Whitehorse City Council submission

Ringwood Activity Centre – Draft Activity Centre Plan

September 2024

FIGURE 1 - RINGWOOD ACTIVITY CENTRE AND CATCHMENT (SOURCE: DRAFT RINGWOOD ACTIVITY CENTRE PLAN AUGUST 2023 [VPA])

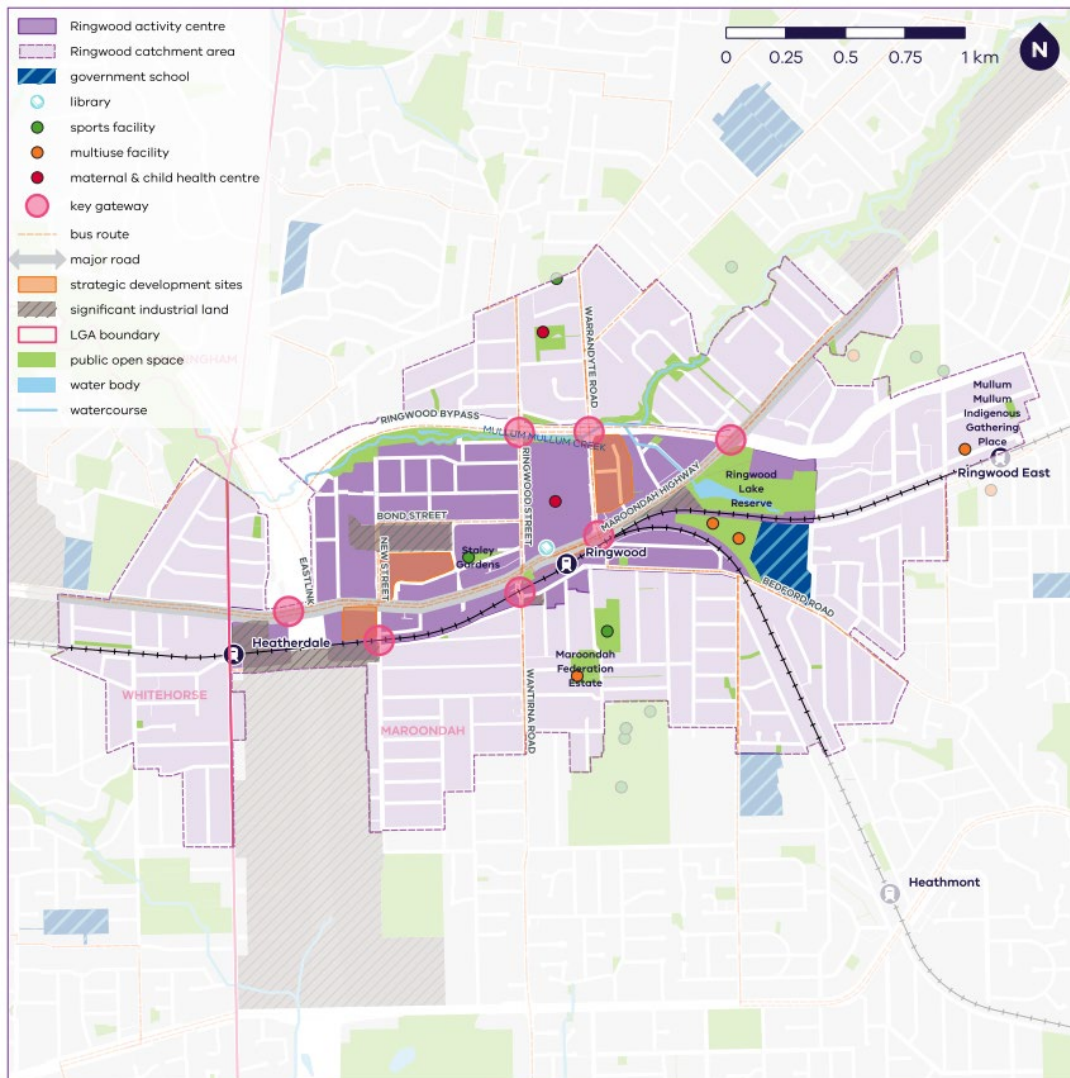
As seen in Figure 1, the draft activity centre plan catchment encompasses part of the City of Whitehorse. To the north of Whitehorse Road the area between Dampier Grove and Deep Creek Road is included. Between Whitehorse Road and the Belgrave/Lilydale railway line the area between Heatherdale Road and Victory Street is included.

There is no recognition in section 2.3 (Catchment area attributes) of the draft Activity Centre Plan that Whitehorse is included in the catchment area and only refers to work undertaken by Maroondah City Council. There appears to be a complete disregard for the fact that there are affected areas that are in a separate municipality.

The method of determining the catchment area in Whitehorse is flawed. The draft Activity Centre Plan states that it is 800 metres from the edge of non-residential areas, however this has been calculated “as the crow flies”, rather than by walking distance or accessibility. The information provided to Council officers at the Directors Update on 24 September 2024 reinforced that the catchment area should be walkable from the core of the activity centre, however this is not the case for the Whitehorse catchment.

Council therefore questions the VPA’s rationale about why this part of Whitehorse was included in the catchment area.

Council therefore requests that the catchment area in Whitehorse be removed from the Ringwood Activity Centre draft Activity Centre Plan. Should any part of the 'catchment' area remain in Whitehorse, Council calls upon the VPA to genuinely engage and consult with Council and Whitehorse residents, including the establishment of a Community Reference Group.

FIGURE 2 - PROPOSED BUILDING HEIGHTS OF ACTIVITY CENTRE AND CATCHMENT (SOURCE: DRAFT RINGWOOD ACTIVITY CENTRE PLAN AUGUST 2024 [VPA])

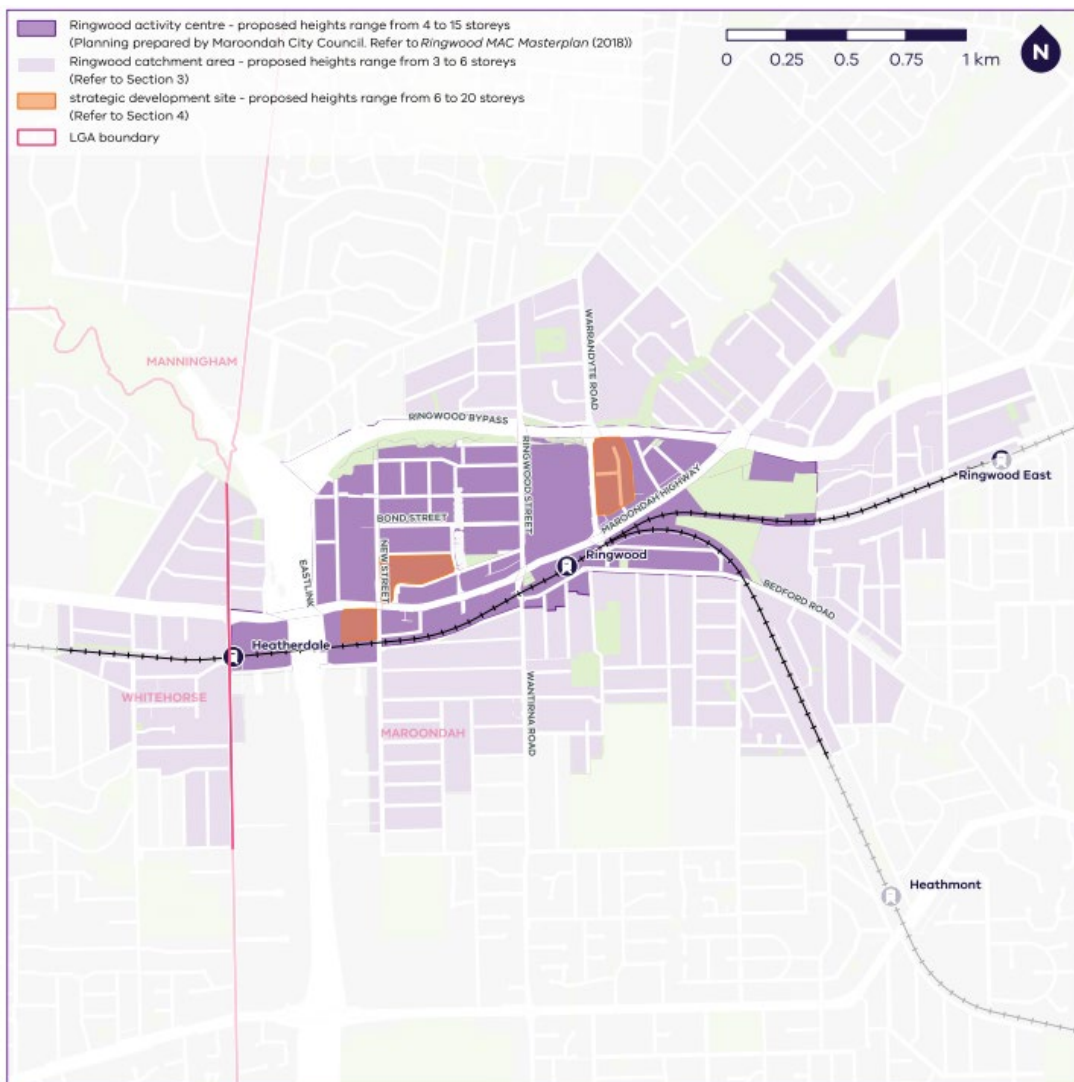
The draft Activity Centre Plan proposes heights from 3 to 6 storeys within the catchment area. It is unclear how many additional dwellings are envisaged in the Whitehorse catchment area.

The *Whitehorse Neighbourhood Character Study* (2014) identified this area as bush suburban with building heights limited to 2-3 storeys. It is therefore concerning that the draft plan proposes heights up to 6 storeys in this area without any supporting strategic justification. There appears to be no consideration of neighbourhood character and Council believes that the proposed height limits will have a significant impact on the neighbourhood character and amenity of this area.

FIGURE 3 - SLIDE FROM MEETING WITH VPA (28 MARCH 2024)

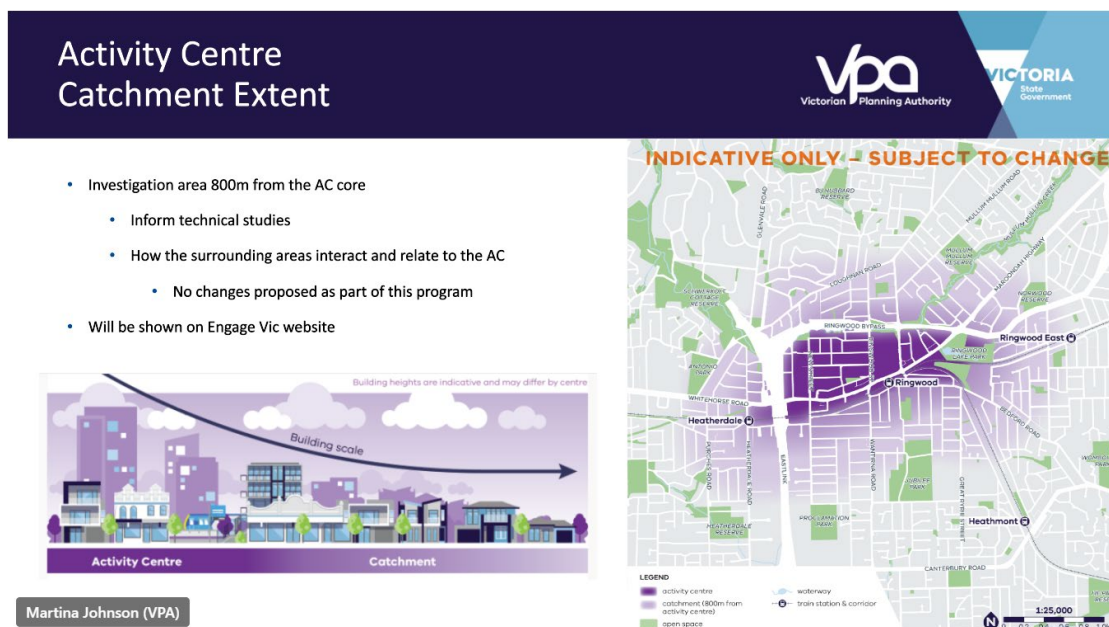
Specifically Council officers were advised that the inclusion of the catchment area was to inform technical studies and investigate how the surrounding areas interact with the MAC. There was not to be any changes to these areas as part of the Activity Centre program. The catchment area was introduced at a later date without a prior briefing of Council and Council did not anticipate the level of change proposed. It should also be noted that 800 metres from the core of the Activity Centre is within the City of Maroondah and not within Whitehorse.
